SERVICE BULLETIN

ENGINE — LP COMPRESSOR — INTRODUCTION OF NEW FAN CASE ASSEMBLY
WITH NEW ACOUSTIC LINING PRIMER

V2500 Series 72-0691

LOCATION OF FAN CASE ASSEMBLY
FIGURE 1

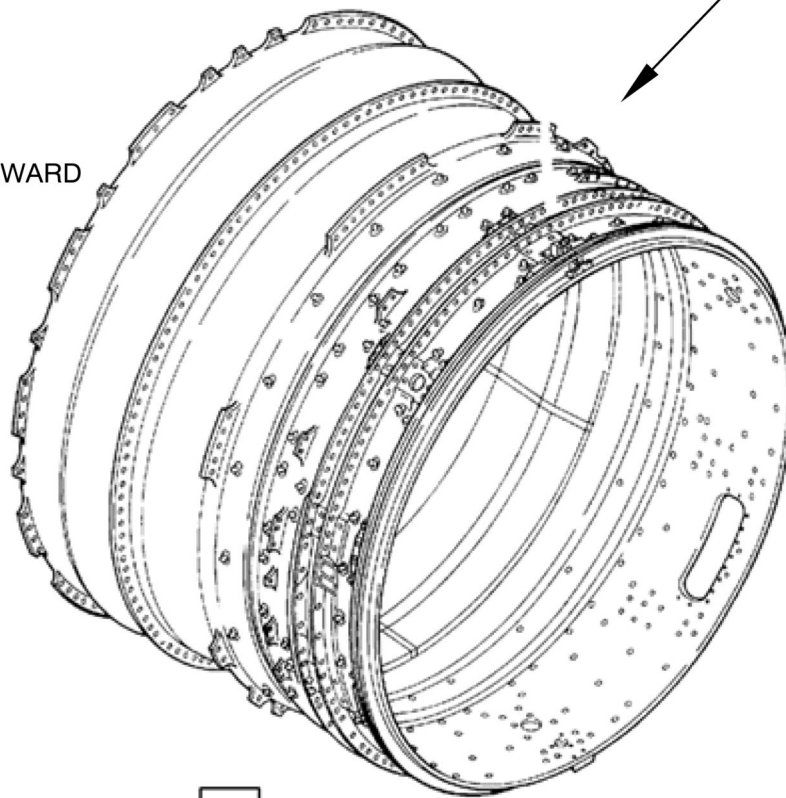
1. Assembly Instructions
 - A. Replace the Fan Case Assembly, PN 5W0307 with PN 5W0313.
 - (1) See Reference 5, Engine Manual, Chapter/Section 72-32-00.
2. Recording Instructions
 - A. A record of accomplishment is required.

5W0307
FAN CASE ASSEMBLY
REPLACE WITH
5W0313

FAN CASE ASSEMBLY
CHART 1

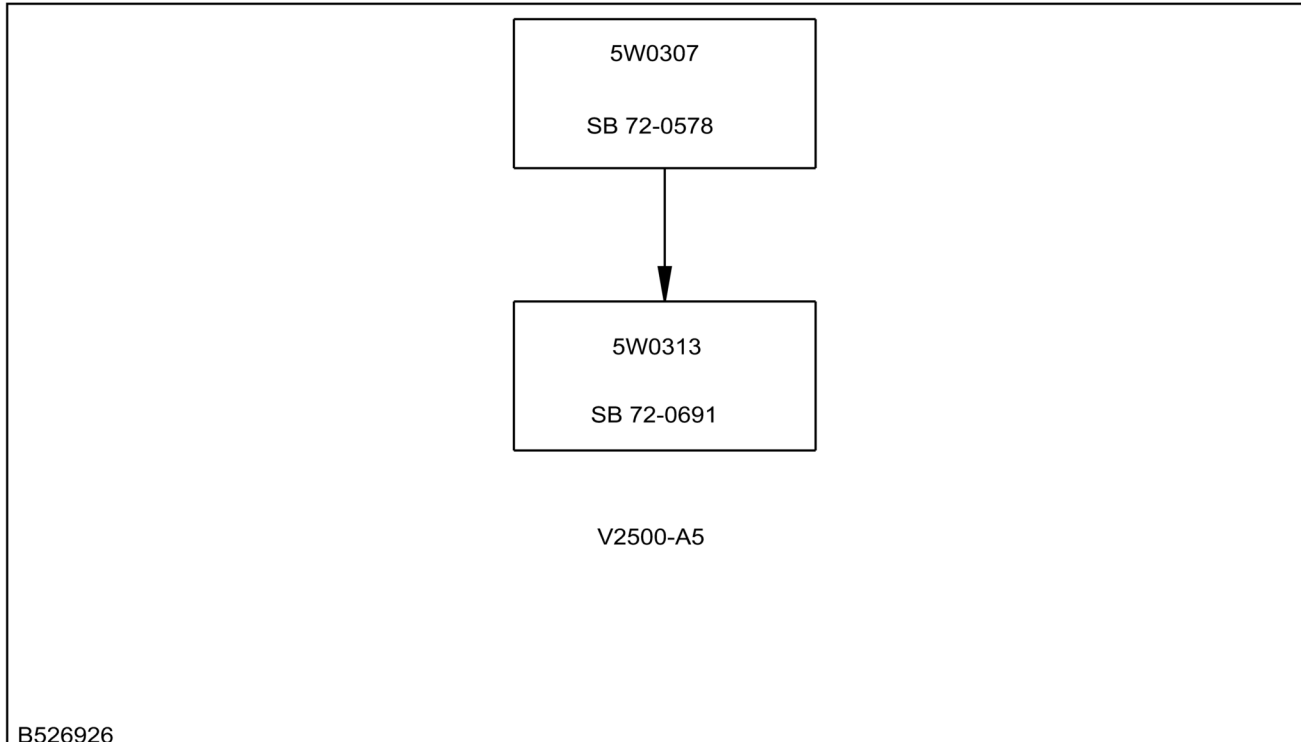
Parts Progression To Show the Changed Part in Relation to Other Parts
